Solicitation Addendum

Addendum No.:	6
Solicitation No.:	23-TA004807DJ
Project No.:	6110580
Solicitation Title:	Force Main 32A Replacement
Addendum Date:	November 15, 2023
Procurement Contact:	Dave Janney, Procurement Agent III

2023-H-194-00027
PLAN SHEET
SHEET NUMBER
C-4
Curtis Vilt
3/7/2023

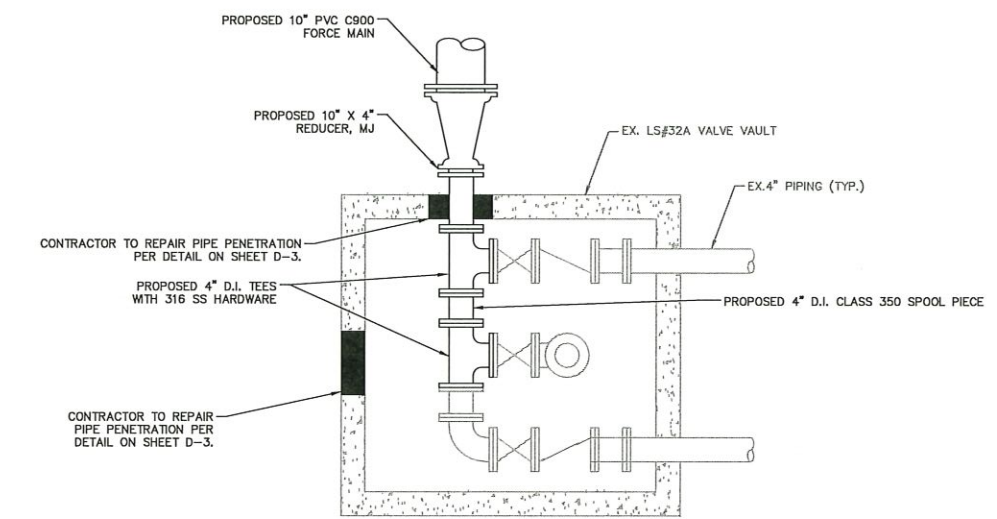
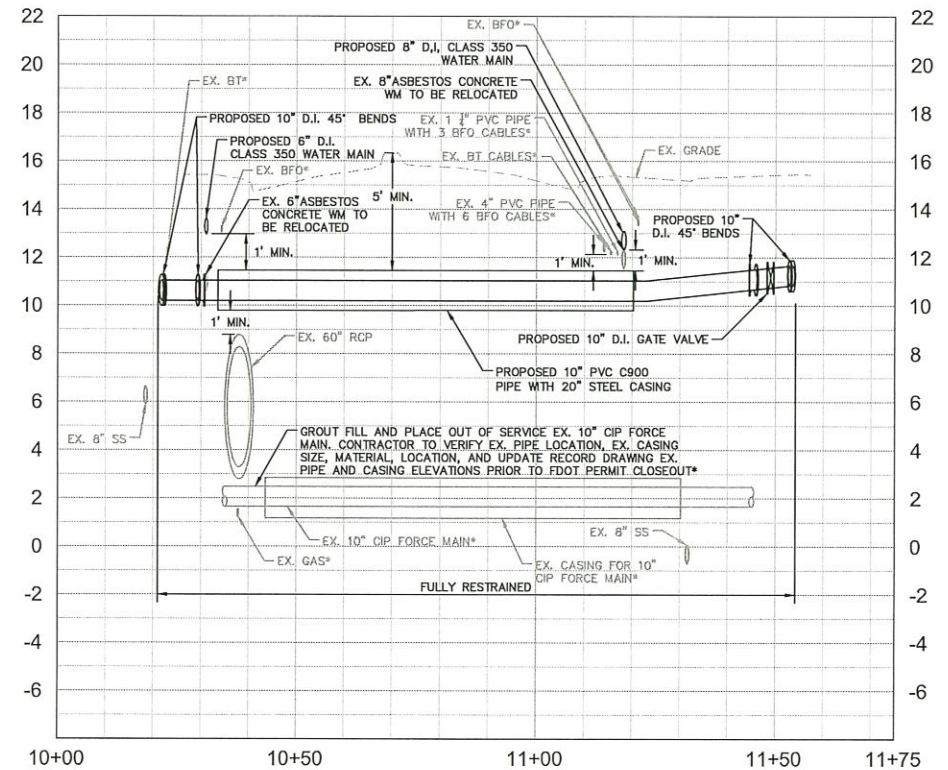
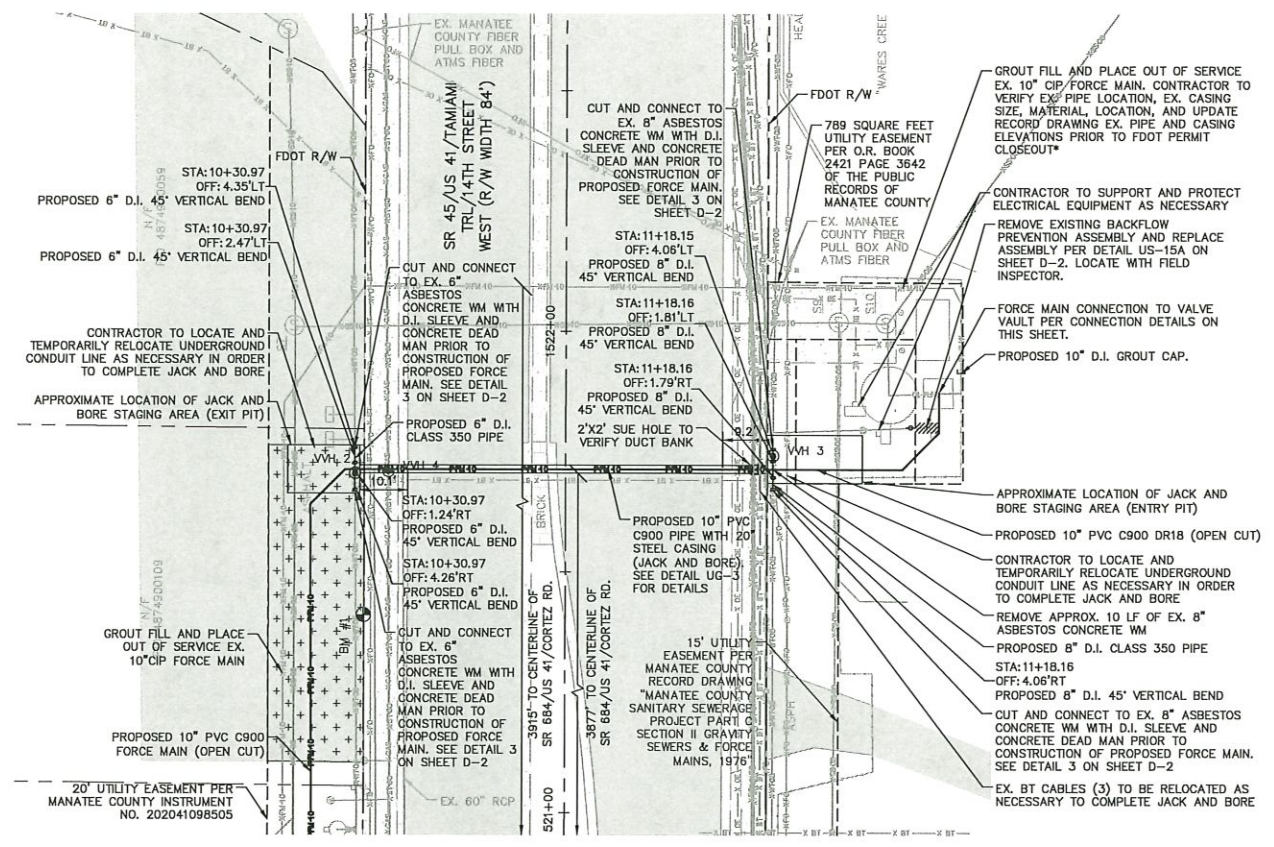
- Q9. Reference plan sheet C-4, the profile view that shows the existing casing for 10” CIP force main, it appears the west end of the existing casing will be under the asphalt at 14th Street West and will require asphalt pavement, base and sub-grade work to be performed after completion of the work for Bid Item 32, please provide an FDOT pavement replacement section for this work.**

- Q10. Reference plan sheet C-4, the plan view of the existing 10” CIP force main at the east side of 14th Street West appears to be under the concrete slab at the lift station, and the profile view of the 10” CIP force main shows the pipe to be fourteen (14) feet deep, excavating down fourteen (14) feet deep and restoration to the impacted surface area just to confirm casing size and elevation is going to be very expensive, does the County really need this information?**

- R9. The FDOT permit requirement is that the contractor is to verify the existing pipe to be placed out of service. This will include elevations of the pipe or casing crossing and the location of the existing crossing. The intent is to no impact FDOT roadway. If the casing is under 14th Street, the contractor will need to obtain an elevation of the existing force main instead.
